<b>Title - Sujet</b> Docking CCGS Edward Cornwallis	
<b>Solicitation No. - N° de l'invitation</b> F5561-150333/A	<b>Amendment No. - N° modif.</b> 004
<b>Client Reference No. - N° de référence du client</b> F5561-15-0333	<b>Date</b> 2015-07-13
<b>GETS Reference No. - N° de référence de SEAG</b> PW-\$HAL-302-9550	
<b>File No. - N° de dossier</b> HAL-5-75032 (302)	<b>CCC No./N° CCC - FMS No./N° VME</b>
<b>Solicitation Closes - L'invitation prend fin</b> <b>at - à 02:00 PM</b> <b>on - le 2015-07-21</b>	
<b>Time Zone</b> Fuseau horaire Atlantic Daylight Saving Time ADT	
<b>F.O.B. - F.A.B.</b> <b>Plant-Usine:</b> <input type="checkbox"/> <b>Destination:</b> <input checked="" type="checkbox"/> <b>Other-Autre:</b> <input type="checkbox"/>	
<b>Address Enquiries to: - Adresser toutes questions à:</b> Gaudreau, Michel	<b>Buyer Id - Id de l'acheteur</b> hal302
<b>Telephone No. - N° de téléphone</b> (902) 496-5245 ( )	<b>FAX No. - N° de FAX</b> (902) 496-5016

**Solicitation Amendment No 004 is issued for the following purposes:**

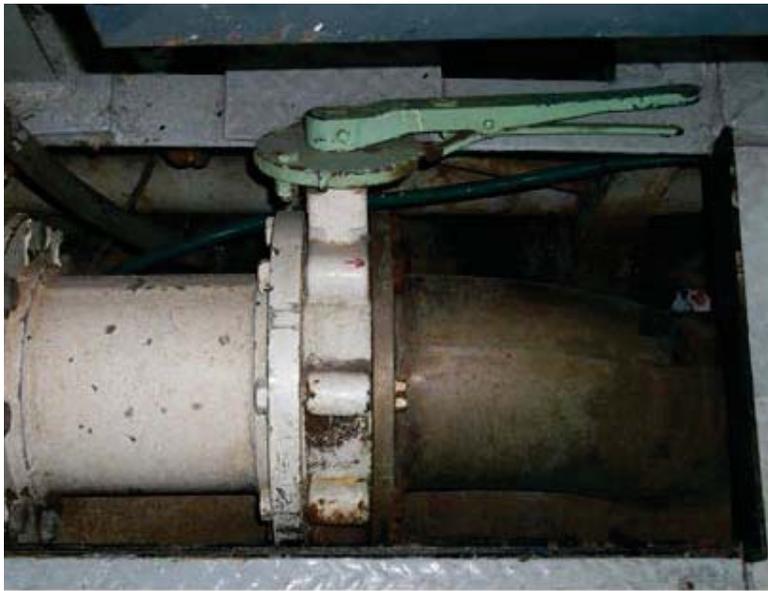
ED-10, Sea Water Pump Valves, in section 2.1 (3) and 2.1 (4), please provide additional information concerning the spool pieces to be removed (length, sketch or drawing,...)

Each spool is approximately 12 inches long. Photo of typical spool is included.
